PARTS LIST

SERVICE CHANGES: TW005G

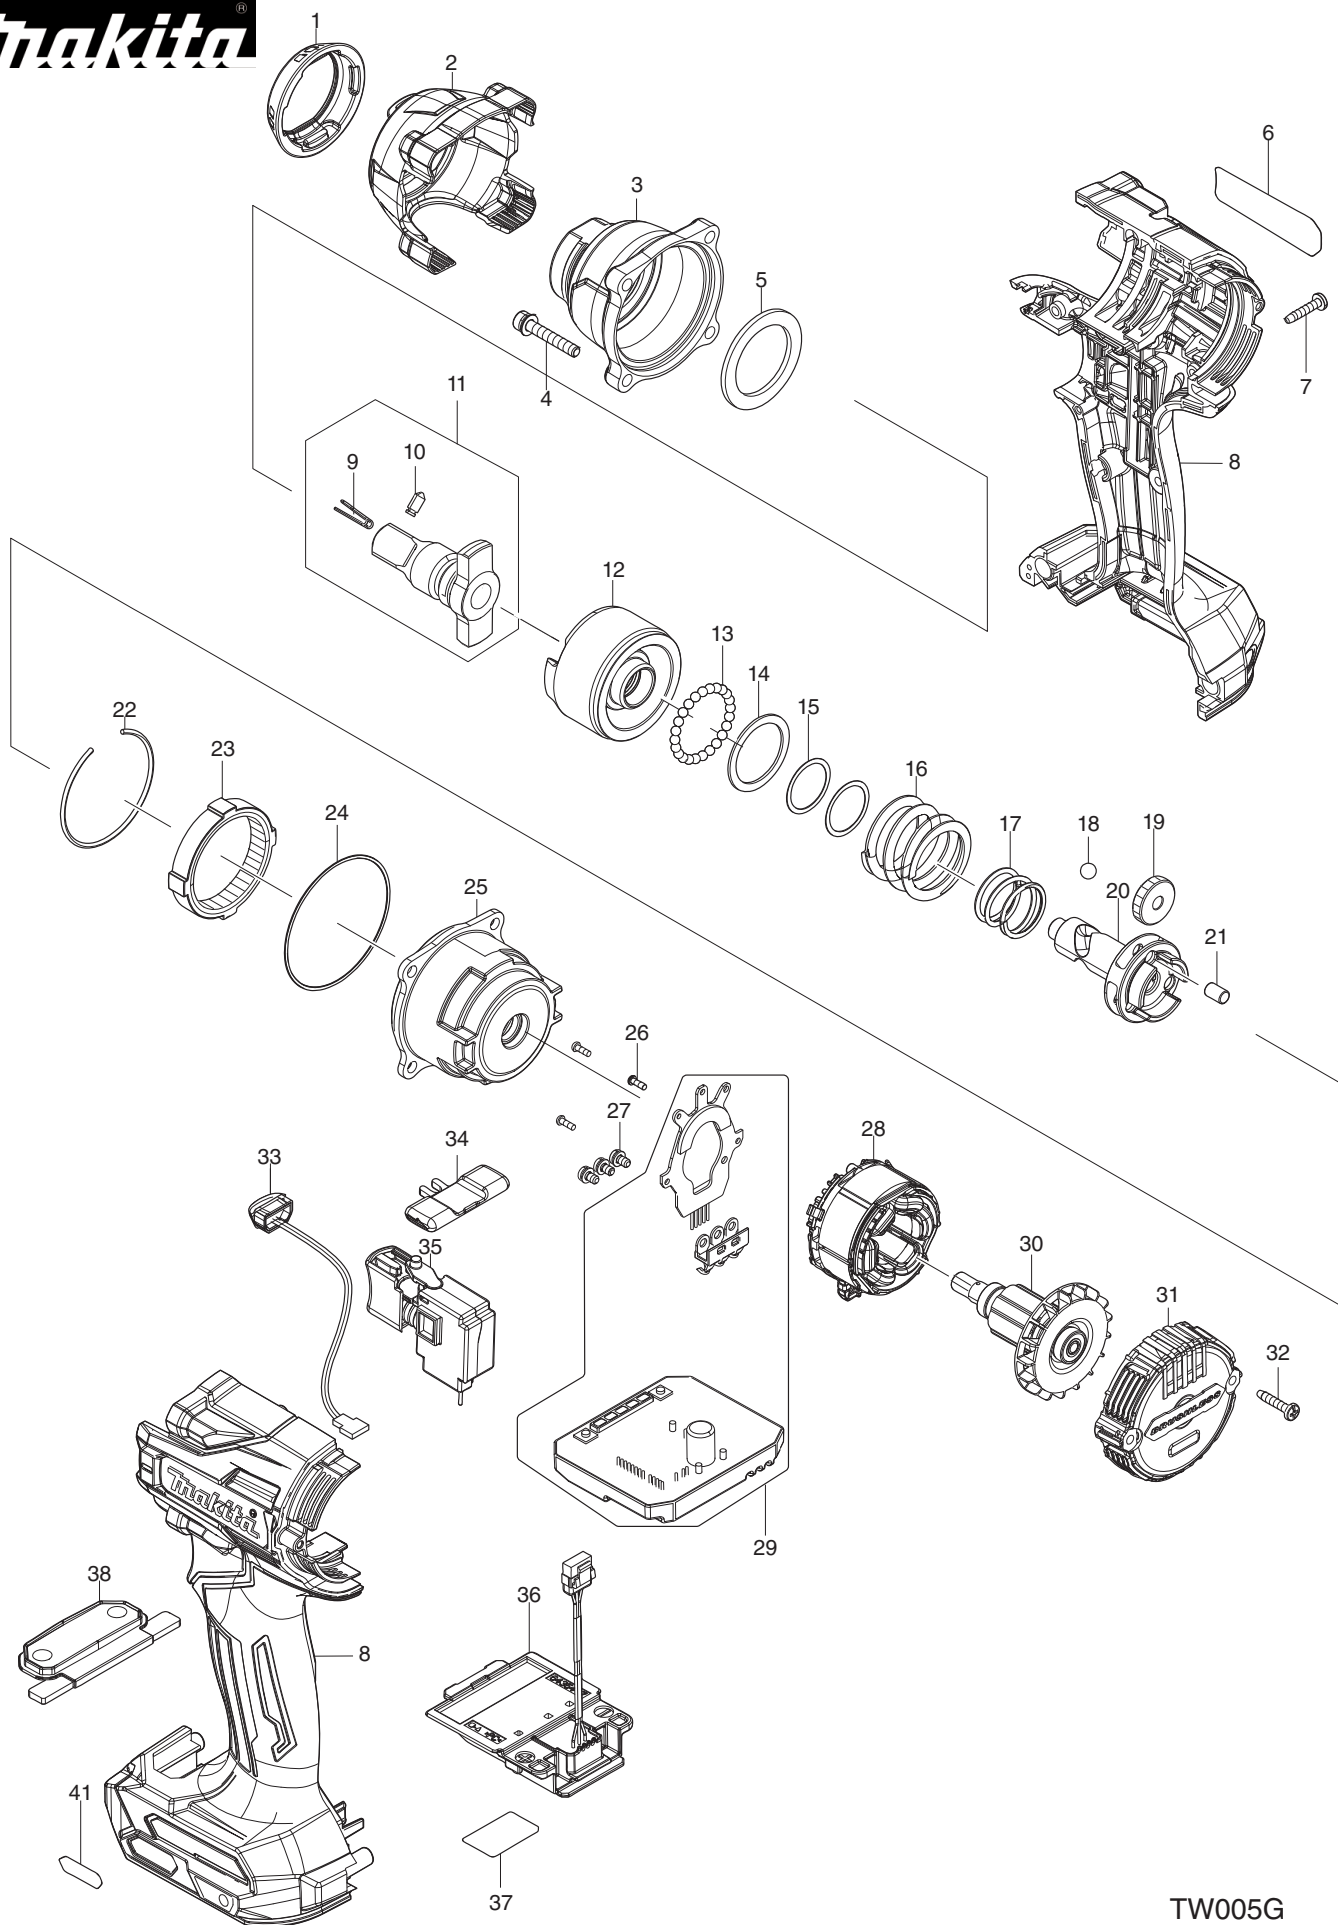
1. Changes on Compression Spring 25 and Steel Ball 3.5 (T/I#E4784)

Item No.	Description	Type 1	Type 2
16	COMPRESSION SPRING 25	232615-7	232910-5
13	STEEL BALL 3.5	216001-0	-----
	STEEL BALL 3	-----	216019-1

Above parts are completely interchangeable as a set.
